ANSWERS TO AEC QUESTIONS

DRESDEN NUCLEAR POWER STATION UNITS 2 AND 3

AMENDMENT NUMBER 16 FOR UNIT 2
AND
AMENDMENT NUMBER 17 FOR UNIT 3

Commonwealth Edison
Company

Figure 6.2.7 Low Pressure Coolant Injection/Containment Cooling System P&ID

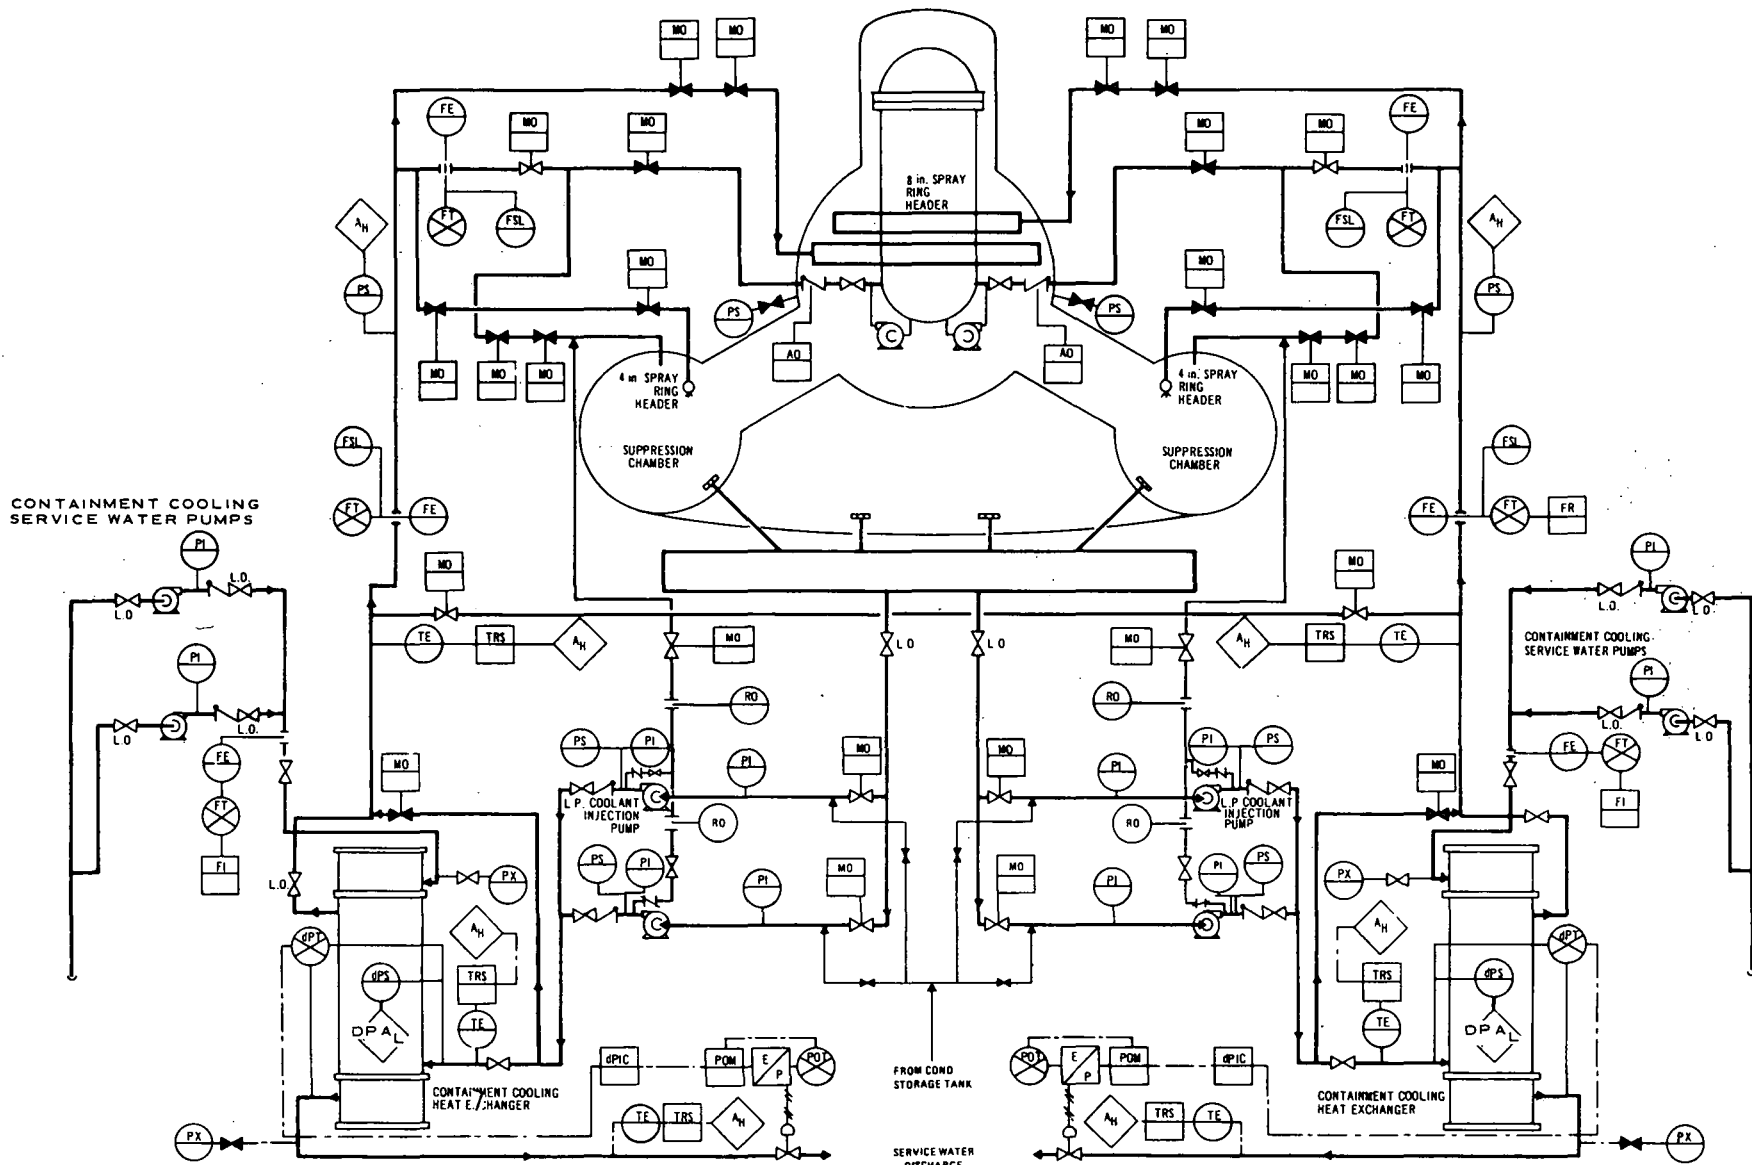
"The containment spray actuation circuitry needs to be made single failure proof."

The containment spray actuation circuitry does not meet the single failure criteria in regard to the two containment pressure switches which prevent the opening of the containment spray valves when containment pressure is less than 1 psig. This circuitry will be modified so that a single failure in this interlock circuitry will not prevent opening of the containment spray valves.

Figure 6.2.16 Automatic Pressure Relief System - Functional Block Diagram

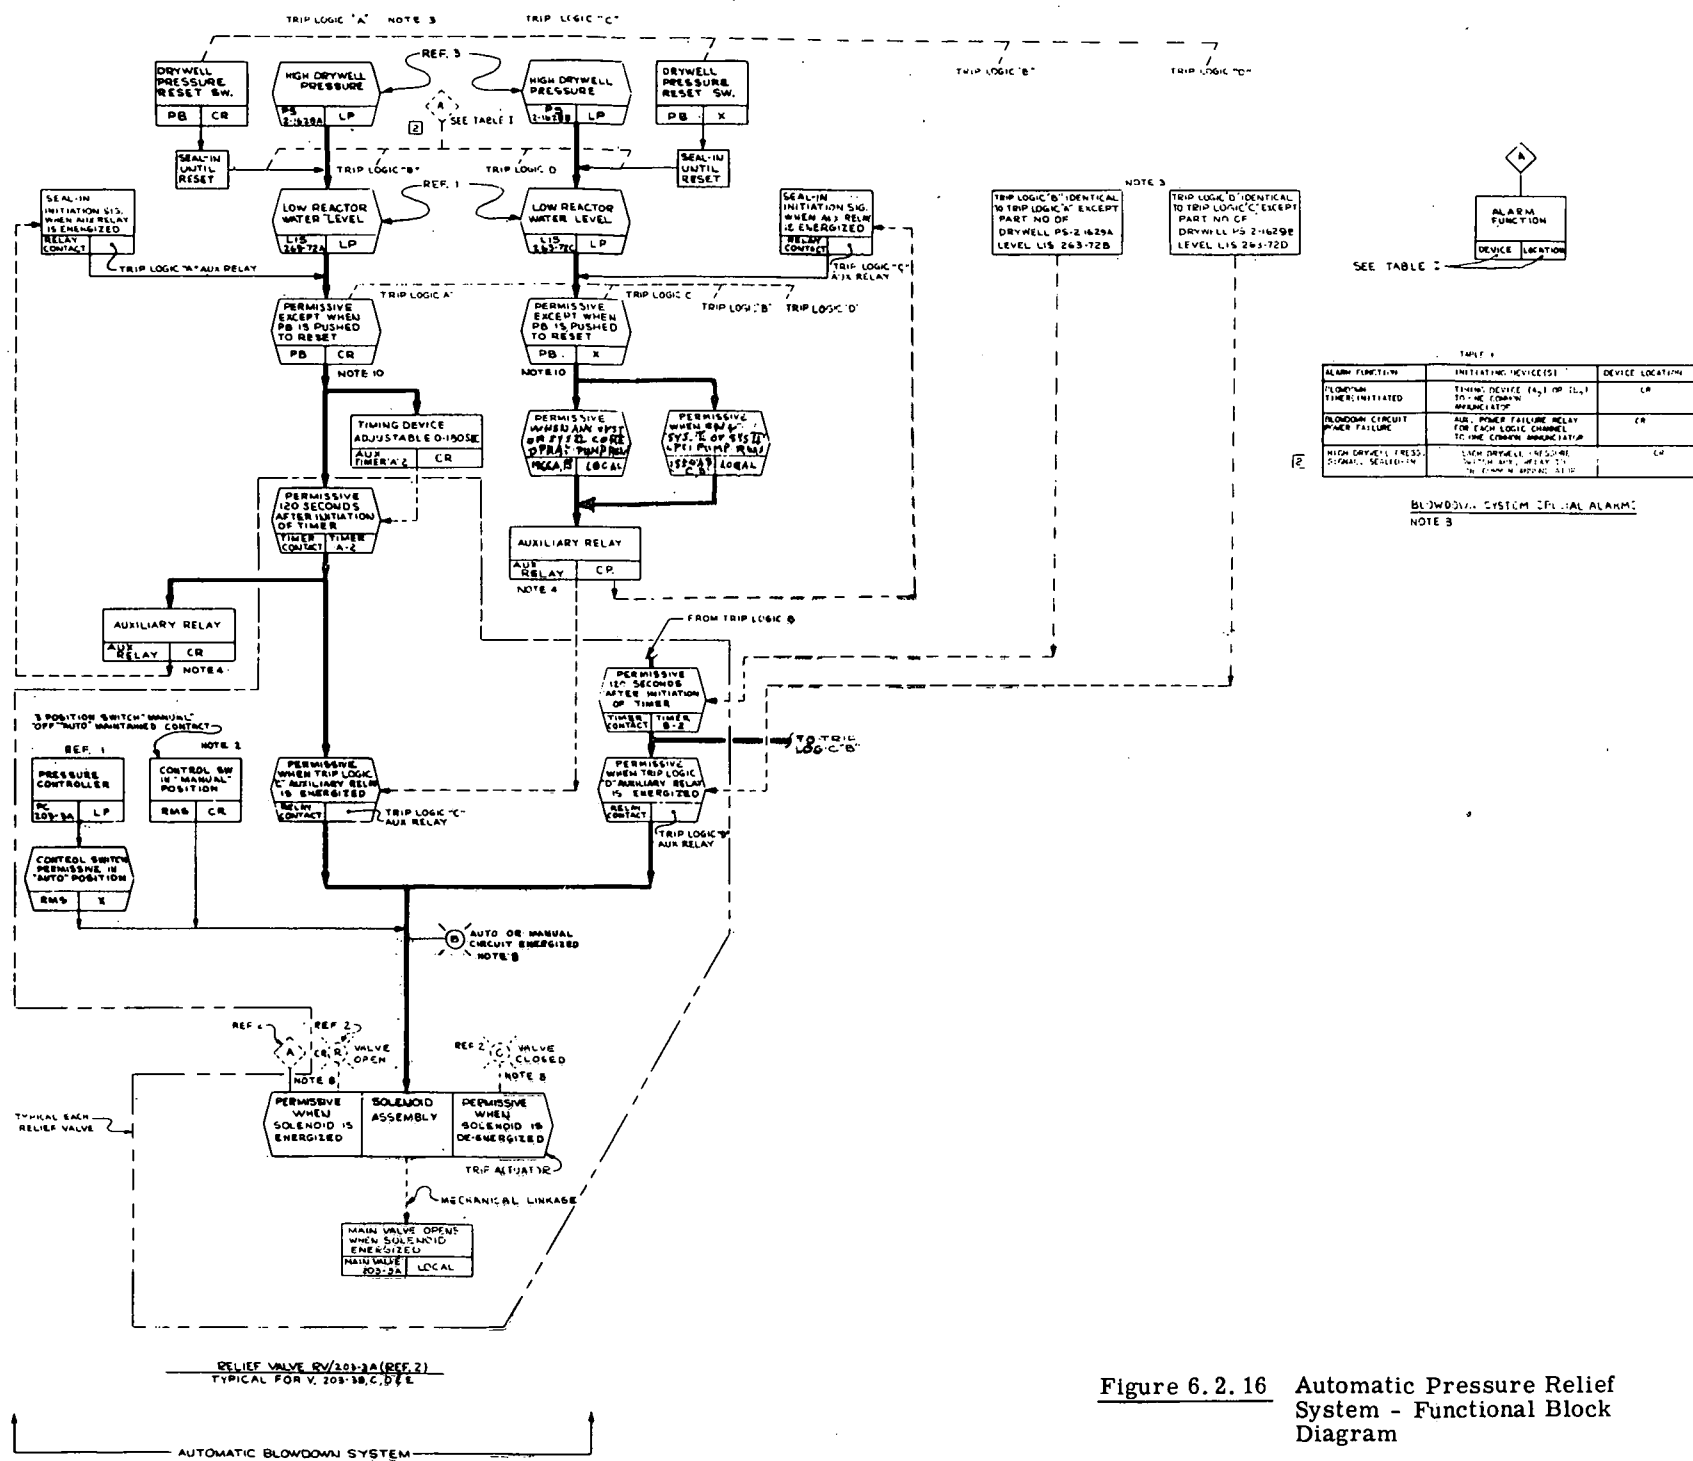
An additional interlock is being added to the automatic blowdown (ABD) system control logic. The design of this "ac interlock" is similar to that used on Oyster Creek. Use of the term ac interlock is somewhat of a misnomer and is better termed "pressure interlock" which describes both the purpose and the function more clearly.

Automatic blowdown requires both a high drywell and low low water signal to occur as well as to maintain the low low water signal for a two-minute period. In addition, the new design incorporates an added permissive in this chain. This permissive prevents actuation of the ABD function until the discharge pressure of at least one LPCI or one core spray pump exceeds 100 psig. This design is a direct indication that the low pressure ECCS pumps are operating and, therefore, that ac power is available to the ECCS systems.

The pressure permissive interlocks are designed to meet the requirements of single failure and separation. Two relays are activated when the pressure switches are closed and these relays provide dual signal paths in each of the two ABD channels. Conversely, failure of any switch or of either relay will not prevent occurrence of ABD should all the other necessary permissives be met.
